From: Tybie House [REDACTED]
Sent: 29 June 2026 08:33
To: Neil Crowther
Cc: Karl Roberts
Subject: Re: A/44/26/PL
Attachments: _ocellaweb3ocellawebdocsplanningdv_pl_filesA_44_26_PL21-254-502E Drainage Construction Details-Sh2.pdf

Job Title
**FORMER SHRUBLANDS NURSERY
ROUNDSTONE LANE, ANGMERING**

Drawing Title
**DRAINAGE
CONSTRUCTION DETAILS (SHEET 2)**

Job No	Drawing No	Rev
21-254	21-254-502	E

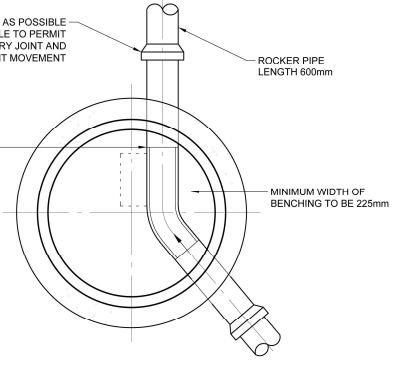
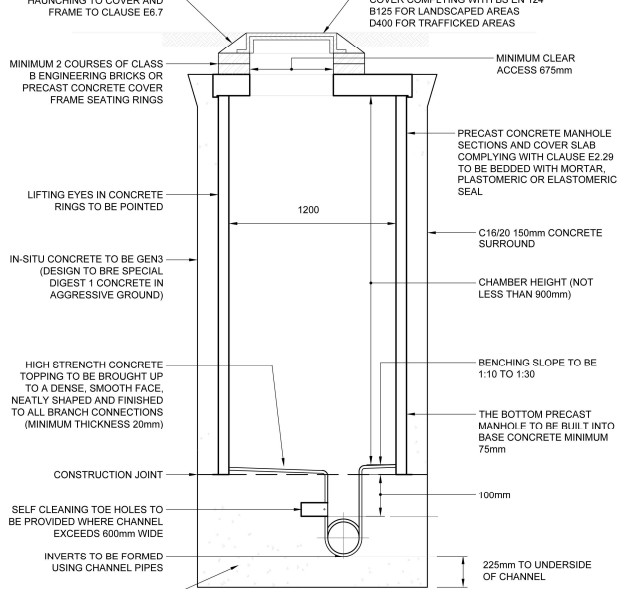
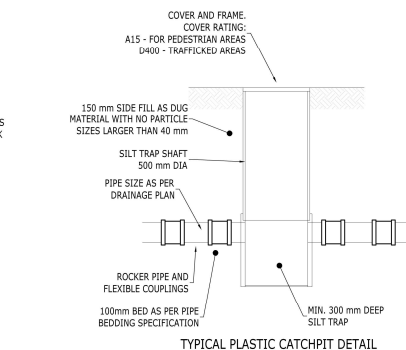
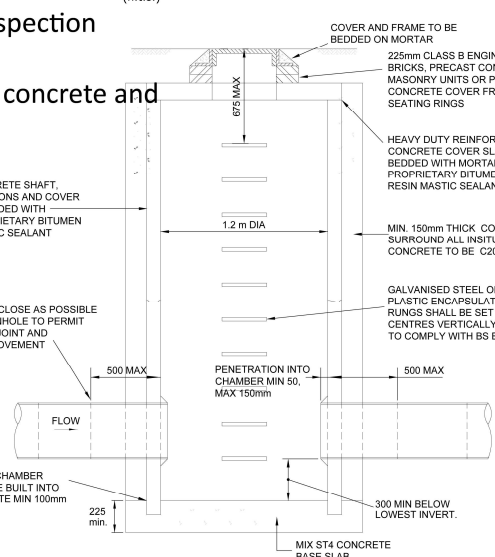
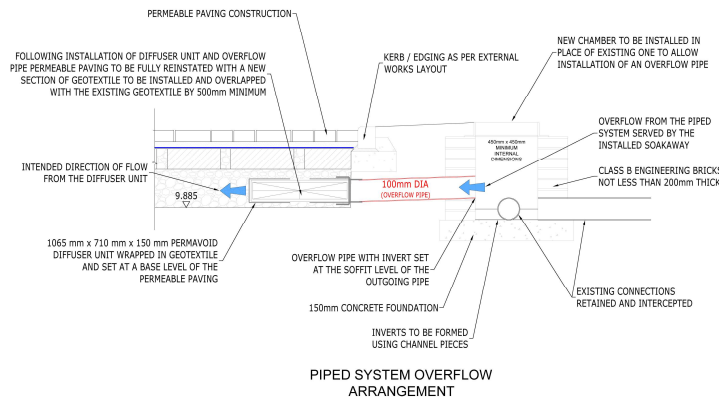
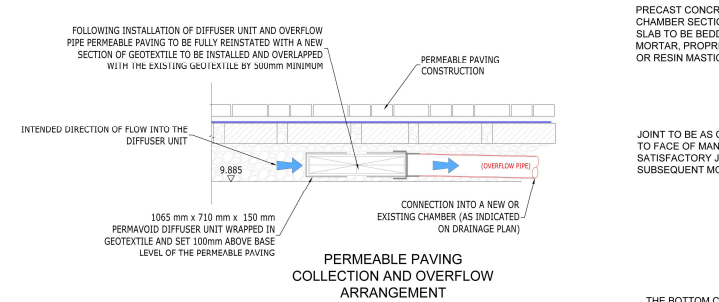
Apologies for another email on the subject, but for the sake of visual clarification, please would you append the attached drawing to my previous email. I feel this helps to explain the necessary accommodation to volumes and areas of SA1.

The RED volumes cannot contribute to storage as they are inspection chambers

The purple areas cannot contribute to infiltration as they are concrete and impermeable
